CZECH SPORT AIRCRAFT	<h2 style="margin: 0;">SAFETY ALERT / SAFETY DIRECTIVE</h2>	Czech Sport Aircraft a.s. Na Záhonech 212, 686 04 Kunovice Czech Republic office@czechsportaircraft.com
No. SA-SC-009		Rev.: -
Date: 2018-11-08		
Page: 1 of 6		Date: -

MODEL AFFECTED:	SportCruiser / PiperSport (except the aircraft under EASA Permanent Flight Conditions).
SUBJECT:	Change of maximum operating temperature limit determination related to the change from the original Cylinder Head Temperature measurement method to the new Coolant Temperature measurement method for aircraft equipped with Rotax 912 ULS2 engines with a new cylinder head design.
AIRCRAFT AFFECTED:	All SportCruiser / PiperSport airplanes from section "MODEL AFFECTED" equipped with Rotax 912 ULS2 engine S/N starting from 6 770 937 inclusive, or with Rotax 912 engines with type designation followed by suffix-01, or with all other Rotax 912 engines equipped with the new cylinder heads design bearing P/N 413185 at cylinder head measuring position 2/3.
COMPLIANCE:	Execution of this Safety Alert is mandatory and must be performed immediately. Instructions contained herein, if not followed, may lead to unsafe conditions, resulting in a

Figure 1: Location of the engine serial number and cylinder head positions

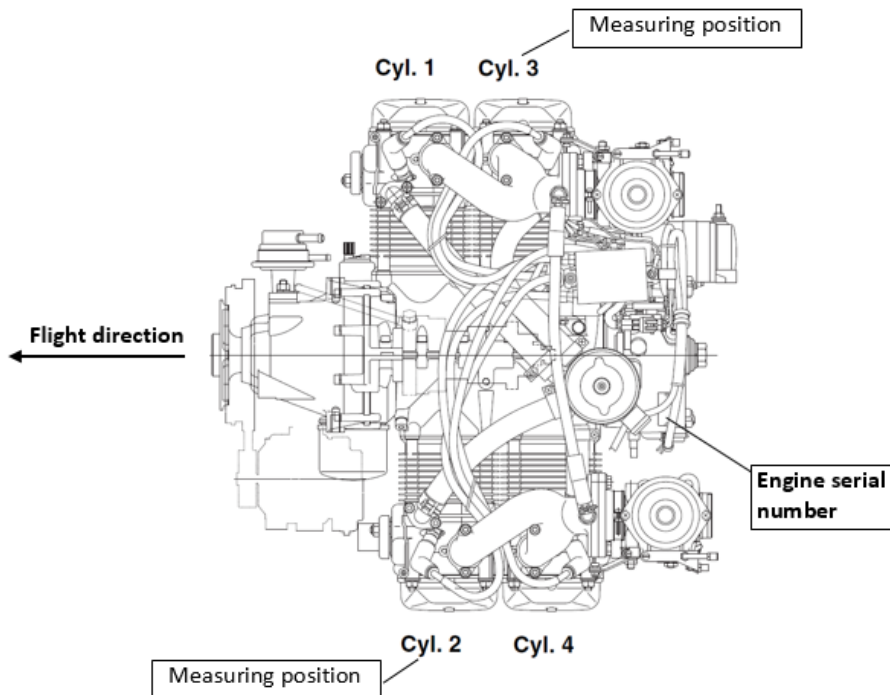
- a) **The engine serial number** is located on the top of the crankcase, magneto side. Basic scheme of the Rotax 912 engine with location of the engine serial number and cylinder heads positions, see Figure 1.

1. Move the aircraft to a suitable place to perform the work. Remove the upper and bottom engine cowlings.
2. Check the engine serial number to find out if the aircraft is affected by this Service Alert, see Figure 1 above.

Figure 2 - Part number location of cylinder head

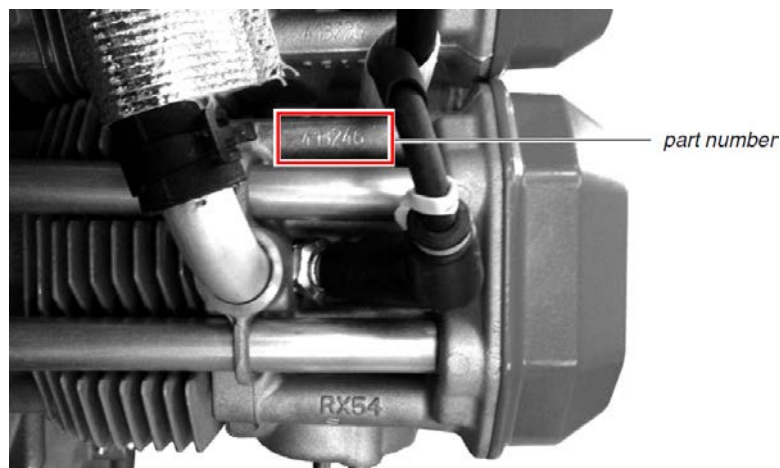
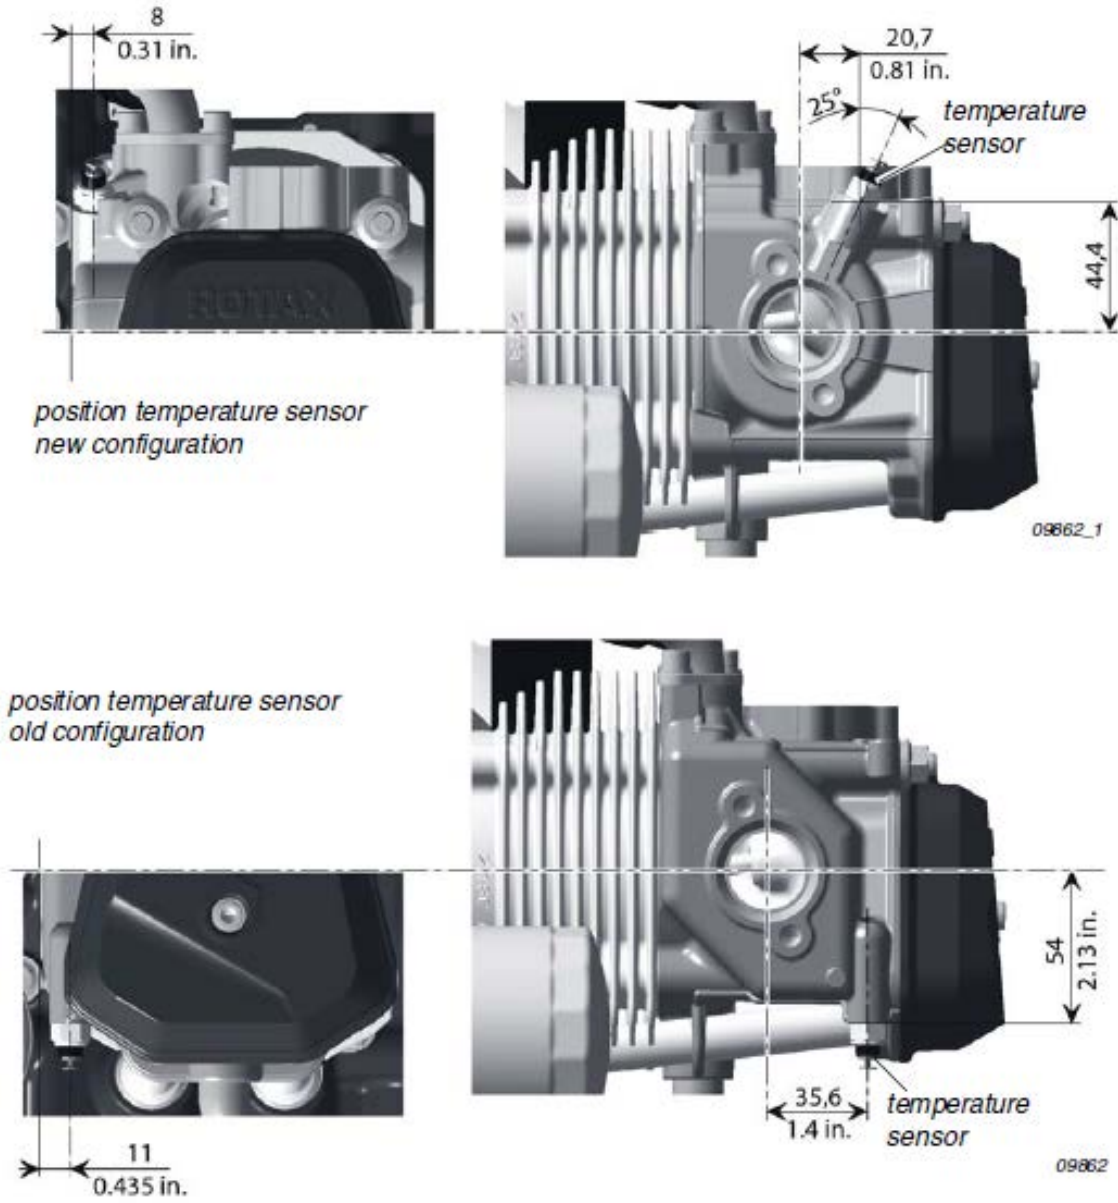
- b) **The temperature sensors** are located on cylinder 2 and 3. For checking whether the engine is equipped with the new cylinder head design (P/N 413185 for 2/3 cylinder head) or not, read the Part number of the 2/3 cylinder heads, see Figure 2.

3. Check the part numbers of the cylinder heads at the measuring positions 2/3, see Figure 1 and Figure 2 above.
4. If the **cylinder heads with the new design are not installed**, enter the aircraft log book and insert the following text: *“The SA-SC-009 applicability has been checked with the result not applicable. Cylinder heads with new design are not installed”*.

5. If the **cylinder heads with the new design are installed** (P/N 413185 at the cylinder head position 2/3), enter the aircraft log book and insert the following text: *“Cylinder heads with the new design are installed. The SA-SC-009 applicability has been checked with the result applicable. The maximum Coolant Temperature limit is 120°C (248°F)”*.
